BULLETIN NO. 12/13/06

TITLE: Vent Hood/Termination Change for Sidewall Venting

MODELS AFFECTED

EV	All sizes
-----------	-----------

FIGURE 1

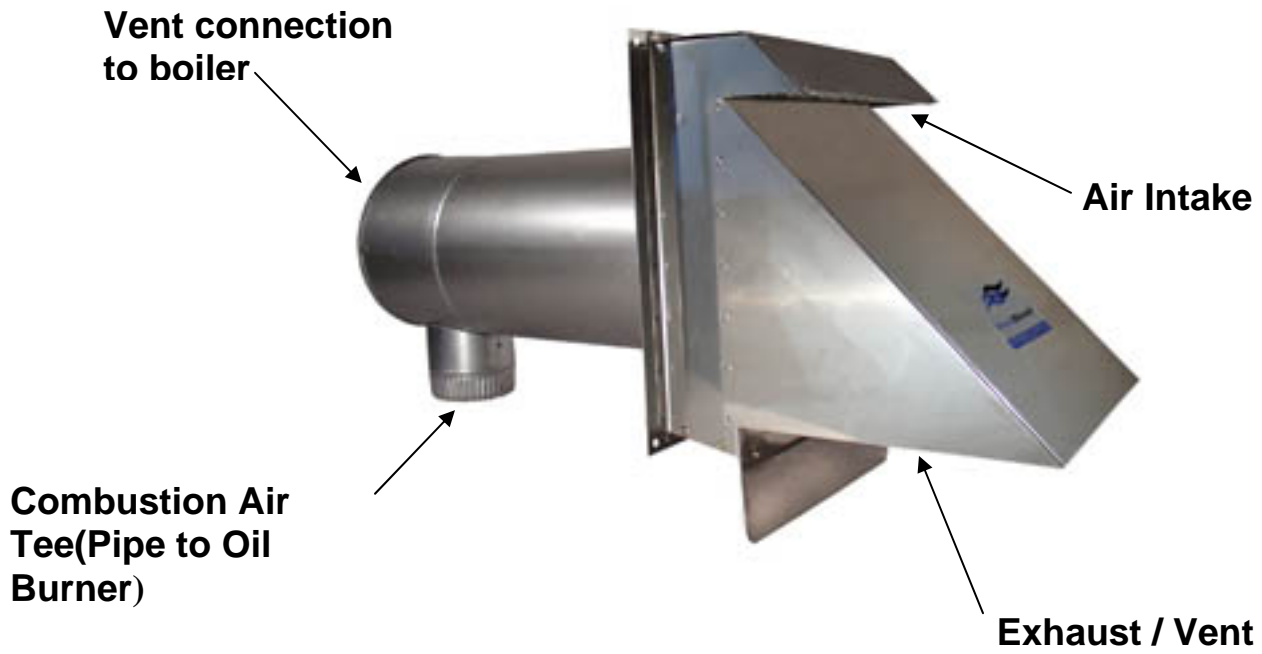
The two-piece air inlet and vent hood termination on sidewall vented EV series boilers has been changed to a one-piece, concentric termination (see figures 1 & 2). This new “concentric” style vent termination results in easier, more flexible installation, improved performance and increased durability:

- The required number of “Through the wall” exterior openings are reduced from two to one.
- There is zero clearance to combustibles (Concentric Termination Only).
- The Combustion Air Tee can be rotated 180 degrees (see figure 1).
- The concentric termination features 40 mph wind resistance.
- The potential for flue gas recirculation into the air inlet and blocked air inlet conditions (i.e. due to snow), are reduced.
- The new concentric termination features durable 316 stainless steel construction.

Due to the change in vent hood design, a change to the boiler’s pressure switch is also required. This new pressure switch, part no. 240005625, is a normally closed switch that opens at 0.035 inches of water column. It is included with each termination kit.
